P-14469-2

S4420

**ISSUE-2**

PARTY'S NAME	ACCUMAX INTERIOR PRODUCTS PVT. LTD., JAMNAGAR
PARTY'S DRAWING No.	AS PER SAMPLE & REQUIREMENT
ALLOY & TEMPER	HE9 WP
DESCRIPTION	MISC. SECTION

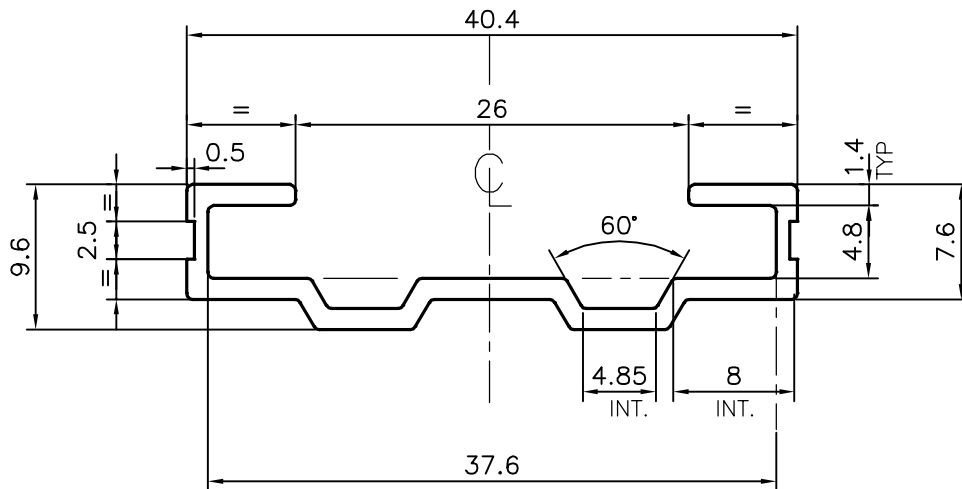
THICKNESS CHANGED FROM 1.2 TO 1.40 mm

DIMENSION CHANGED FROM 40 TO 40.4, & FROM 9.0 TO 9.6 mm &

OTHER DIMENSION CHANGE ACCORDINGLY.

WEIGHT ALSO CHANGED FROM 0.193 kg/m TO 0.254 kg/m
